RENESAS TECHNICAL UPDATE

Product Category	MPU & MCU	Document No.	TN-16C-A193A/E	Rev.	1.00
Title	Errata to R32C/151 Group Hardware Manual	Information Category	Technical Notification		
Applicable Product	R32C/151 Group	Lot No.	Reference Document	R32C/151 Group Hardware Manual Rev. 1.03 (REJ09B0503-0103)

This document describes corrections to the R32C/151 Group Hardware Manual, Rev. 1.03.
The corrections are indicated in red in the list below.

Figure 24.32 LINi_j Interrupt Block Diagram (i = 0, 1; j = 0 to 3)

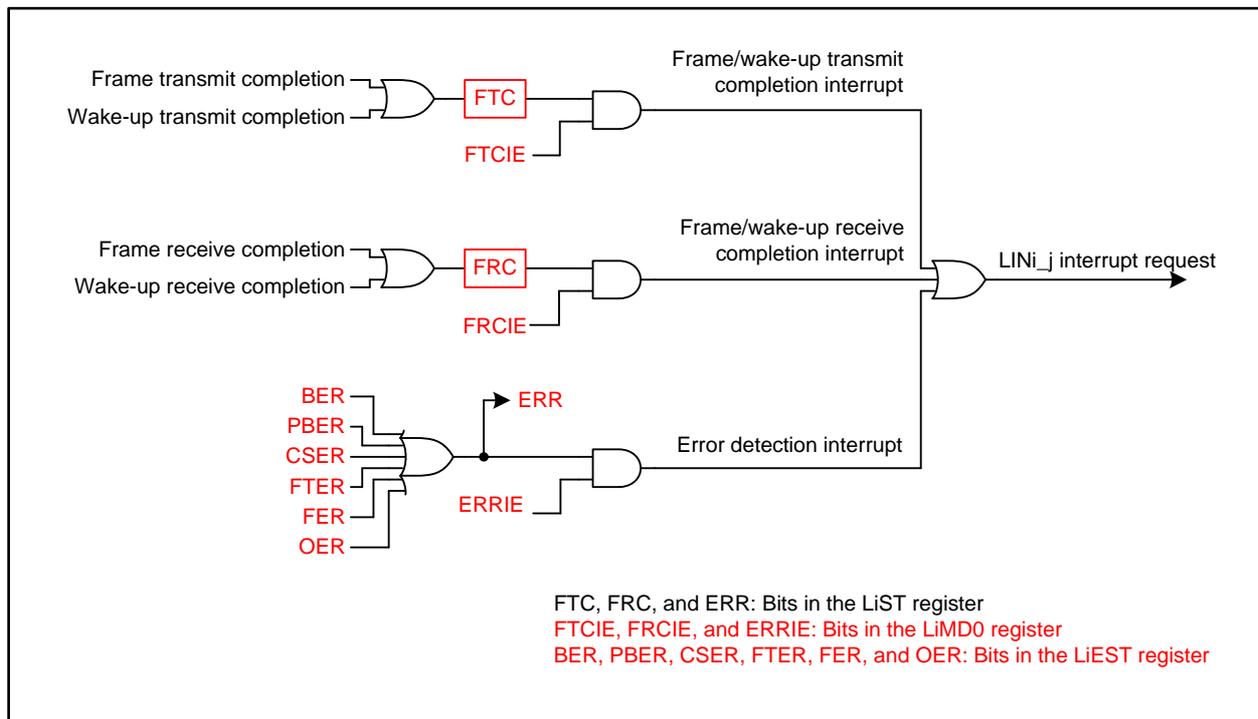
- Page 420 of 624, description for Detecting Condition for Input signal low detection in Table 24.8 is changed as follows:
 “When the falling edge of input signal at the LINi_jIN pin is detected with the setting of the LDE bit in the LiMD0 register to 1 (Input signal low detection enabled), or when setting the LDE bit to 1 while the LINi_jIN pin is low.”
- Page 421 of 624, value range “; j = 0 to 3” in the title of Table 24.9 is deleted.
- Page 423 of 624, description in lines 9 to 10 of 24.11 is added as follows:
 “The respective interrupt request is output when the corresponding flag in the LiST register becomes 1 while the corresponding bit in the LiMD0 register is set to 1 (interrupt enabled). No new interrupt request is generated by the other sources if any of them is 1 since multiple interrupt sources are aggregated.”
- Page 423 of 624, Figure 24.32 is corrected as follows:

Figure 24.33 LINi Low Detection Interrupt Block Diagram (i = 0, 1)

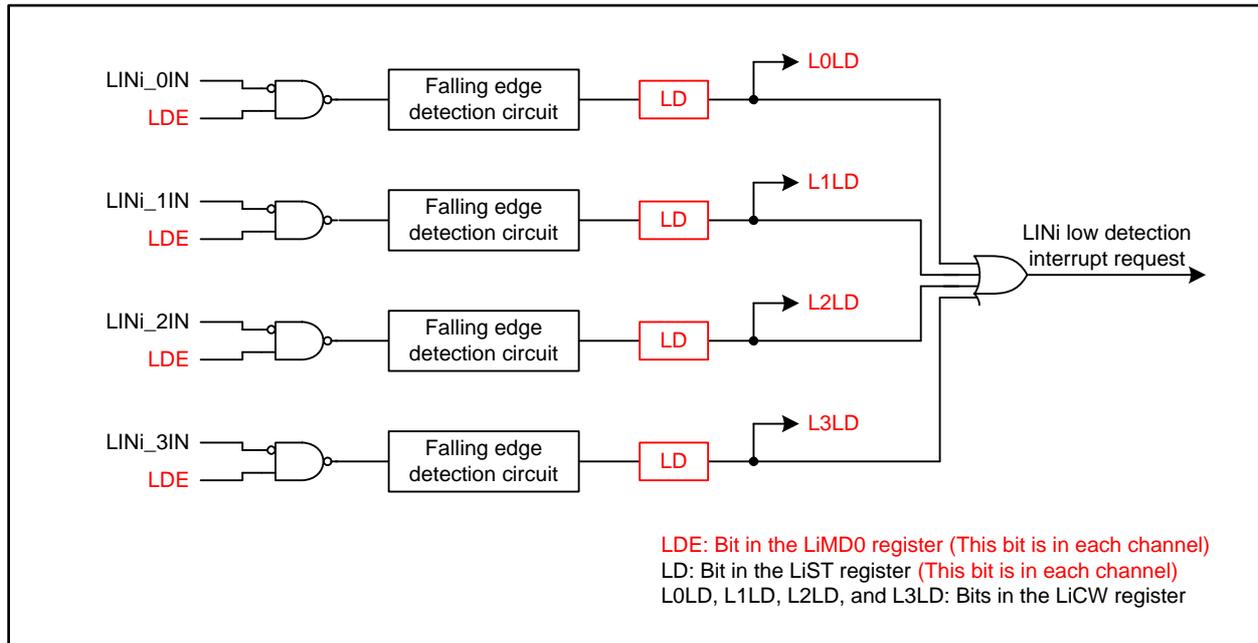
•Page 424 of 624, Figure 24.33 is corrected as follows:

Figure 27.2 Addresses for ID Code Stored

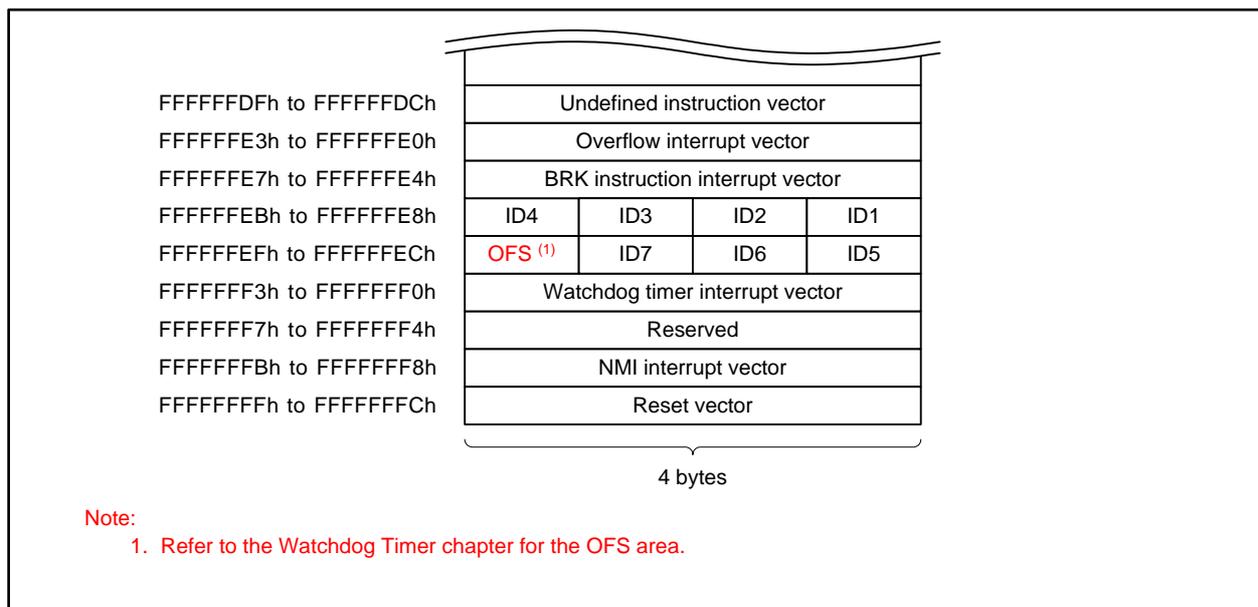
•Page 529 of 624, Figure 27.2 is corrected as follows:

Figure 27.13 Read Timing

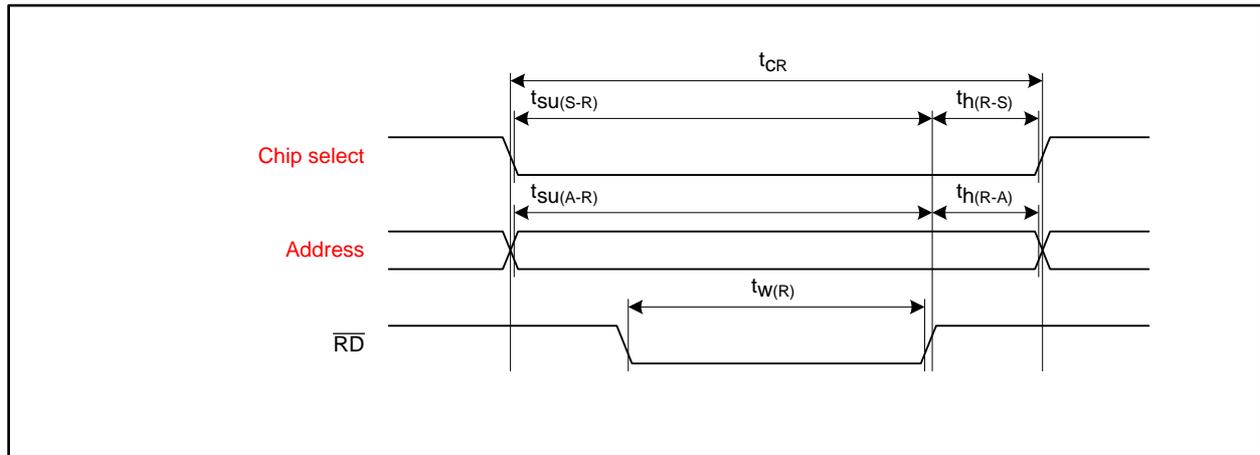
- Pages 538 and 540 of 624, descriptions in Figures 27.13 and 27.14 are corrected as follows:

Figure 29.5 Flash Memory CPU Rewrite Mode Timing

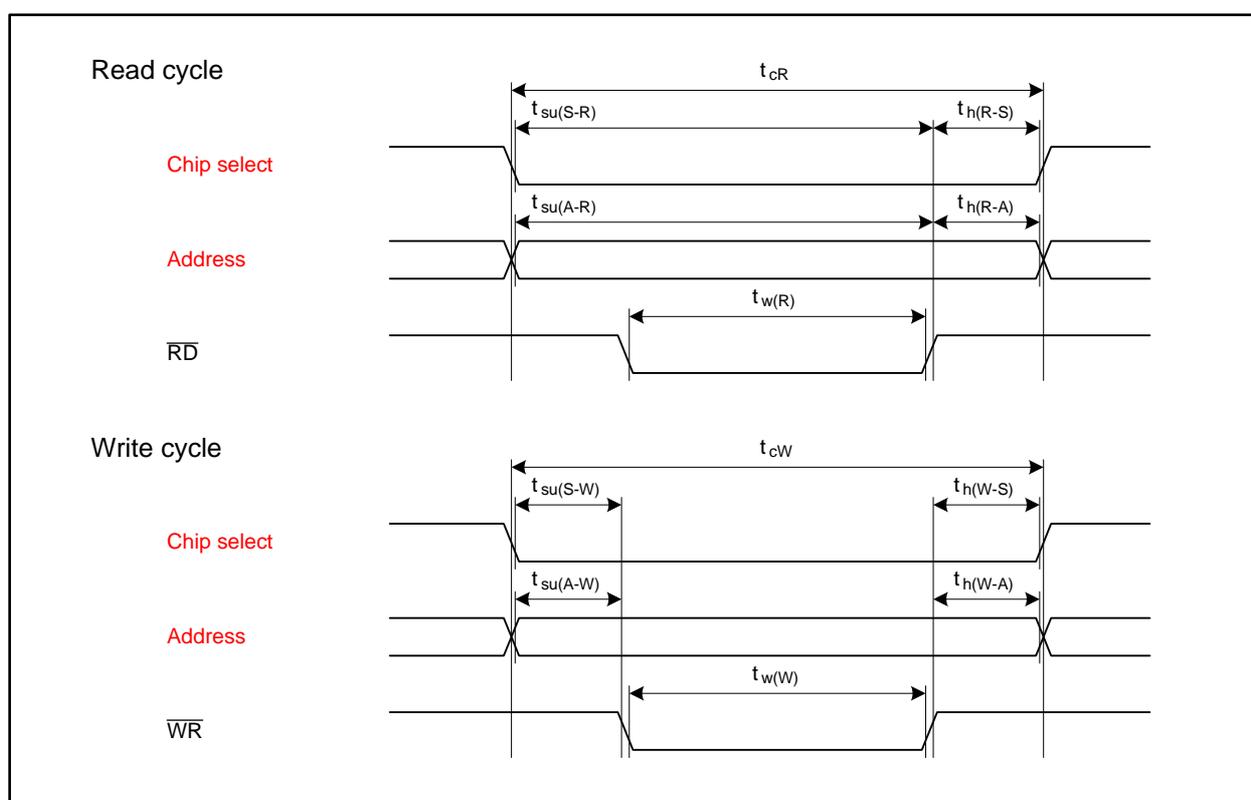
•Page 577 of 624, descriptions in Figure 29.5 are corrected as follows:
